TECHNISCHE MITTEILUNG |TECHNICAL NOTE

201-20 Nr:205-6, 206-3 301-30

Reinforcement of the elevator assembly guides.

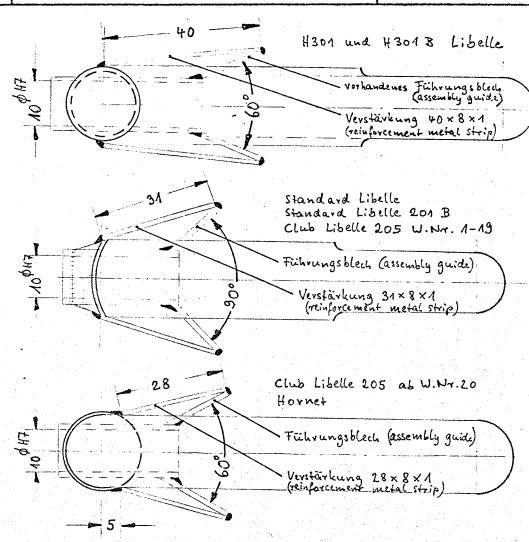
Careless assembly of the tailplane caused damaged elevator assembly guides, resulting in a possible improper assembly of the tailplane and loss of elevator control.

- With a 5 x powered magnifier visually inspect the assembly guides for distortion, bending and/or for cracks in the welded seam.
- 2. If damage is found replace the bracket immediately with a bracket to be reinforced according to method 4.
- 3. If no damage is found replace the bracket with a bracket to be reinforced according to method 4 before the date quoted in "Urgency".
- 4. Weld in two sheet metal strips according to the following drawings to reinforce both guides. (see next page)

Sheet metal to specification 1.7214.4 or 1.7734.4, welding material to specification 1.7734.2 or 1.7324.0, welding process WIG (Wolfram-Inert-Gas). After removing the bracket insert a pin 10 mm Ø into the tube instead of the actuator pin to prevent warping during welding. It should be possible to insert this pin simply by hand. Remove the pin after the bracket has cooled down. Preserve the bracket again (recommended single component primer B 1742 from Lackfabrik Bäder and nitro lacquer). Fit the bracket to the tailplane and pay attention to the 2 washers between bracket and ball bearings.
